Service Bulletin

Conversion of aircraft from FAA certificated FAR23 Amendment 54 status to CASA certificated FAR23 Amendment 54 status.

All GA8 aircraft serial numbers that have incorporated Service Bulletin SB-GA8-2003-05.

Figure 1 – Gate installation

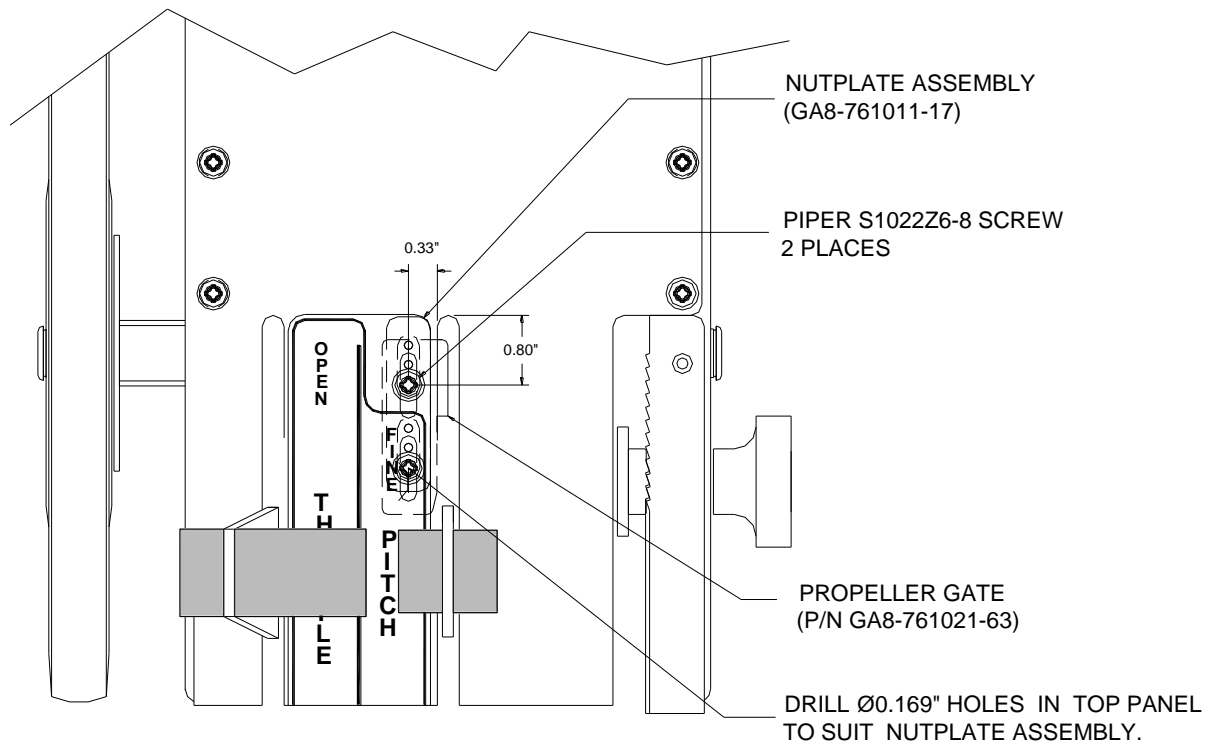
1. Remove existing throttle quadrant placards.
2. Install new throttle quadrant placards (P/N GA8-112011-163 and GA8-112011-165).
3. Install propeller gate (P/N GA8-761021-63) and nutplate assembly (P/N GA8-761011-17). Refer to Figure 1.

Figure 2 – Completed installation

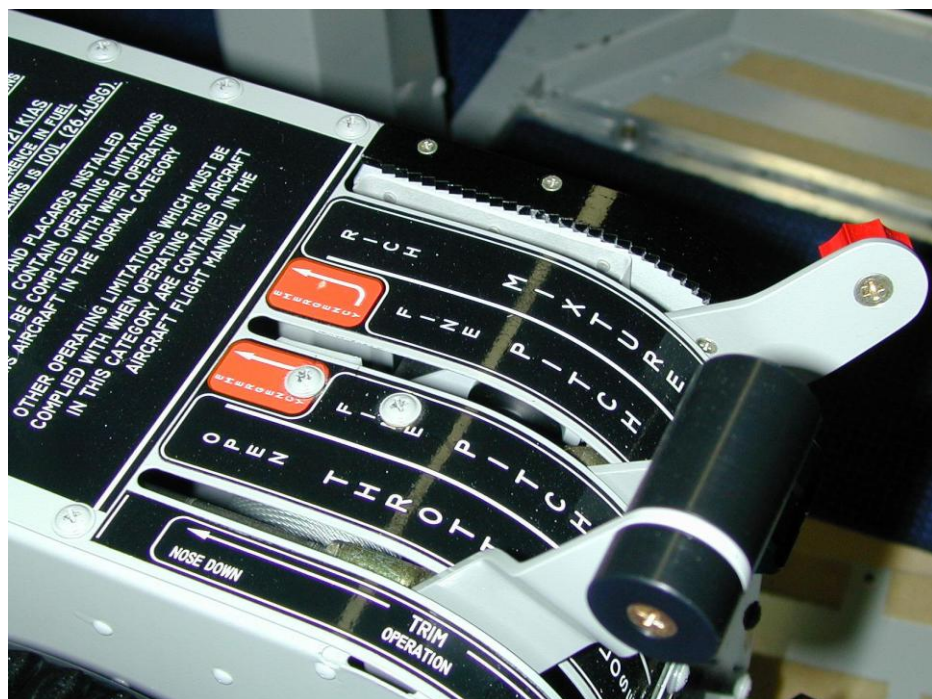
4. To set take-off rpm:
 - (i) loosen propeller gate attaching screws.
 - (ii) start engine and allow to warm up.
 - (iii) cycle propeller control several times to ensure that warm oil has circulated through the propeller.
 - (iv) retard propeller control until 2500 rpm is set on the tachometer.
 - (v) set propeller gate abutting the propeller control and tighten attach screws

Figure 3 – Tachometer marking

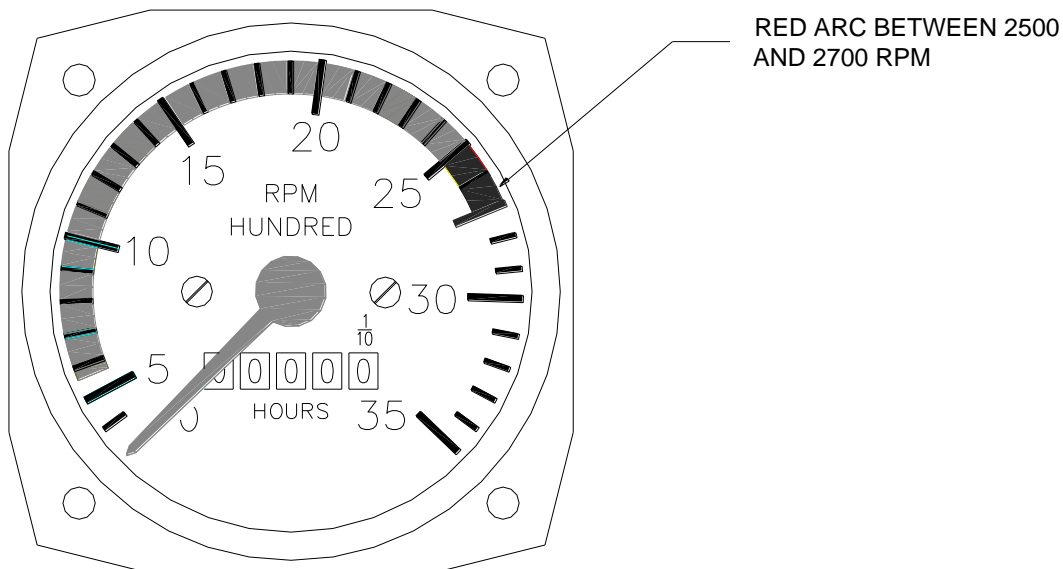
Alternatively, the existing tachometer may be reworked by re-marking the existing yellow arc between 2500 rpm and 2700 rpm with a red arc. Refer to Figure 3. Re-identify the tachometer as GA8-771013-11.
